TECHNICAL BULLETIN
K407 UPS4816-6bNAS1
14 JUL 2016

Update Prior to Sale: AWD V6 Petrol S/C Cross Brace Foul

XE (X760)

E194840

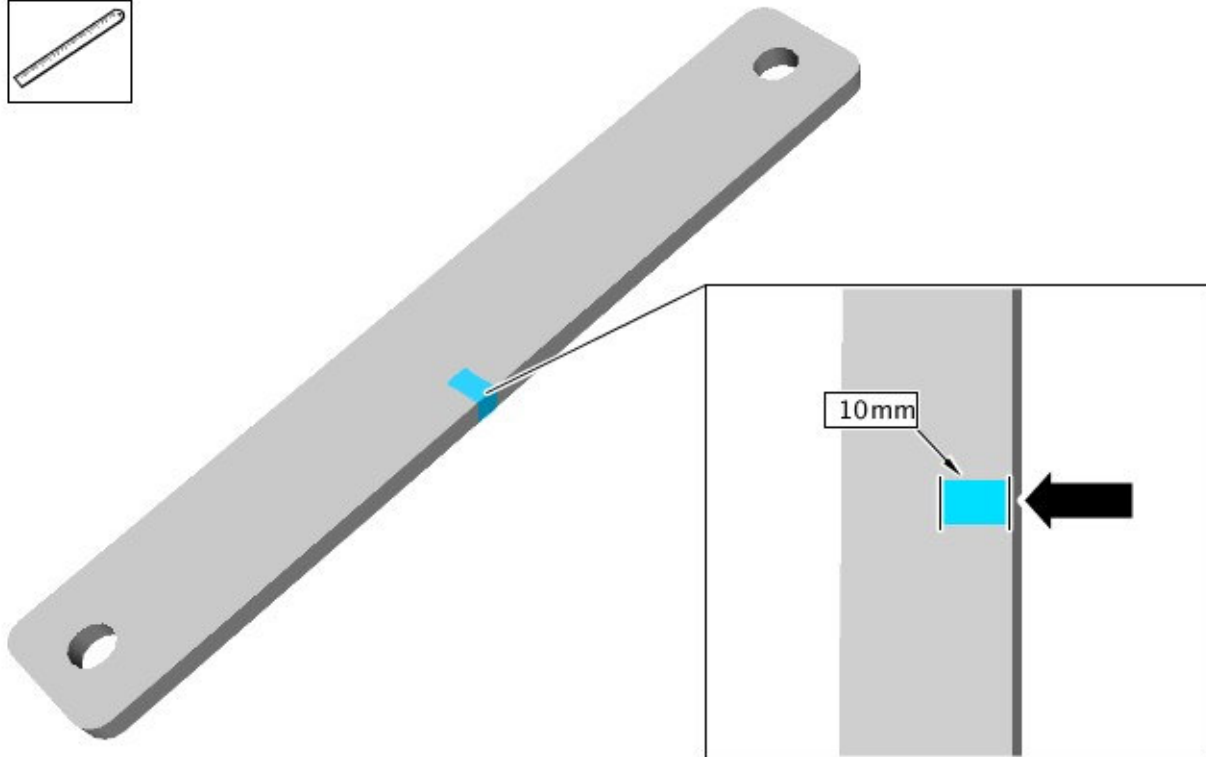
5.  **NOTE: If the contact damaged length is more than 10mm, submit an Electronic Product Quality Report (EPQR), including a picture of the cross brace damage.**

Inspect the cross brace contact damaged length.

- If the contact damaged length is less than 10mm, discard the cross brace, clean the damaged area on the driveshaft, and paint with Rust-Oleum High Heat Black (248903).
 - Continue to Step 6.
- If the contact damaged length is more than 10mm, discard the cross brace, install a new driveshaft (see TOPIx Workshop Manual section 205-01: Driveshaft), and release the vehicle.
 - Submit an Electronic Product Quality Report (EPQR), including a picture of the cross brace damage.
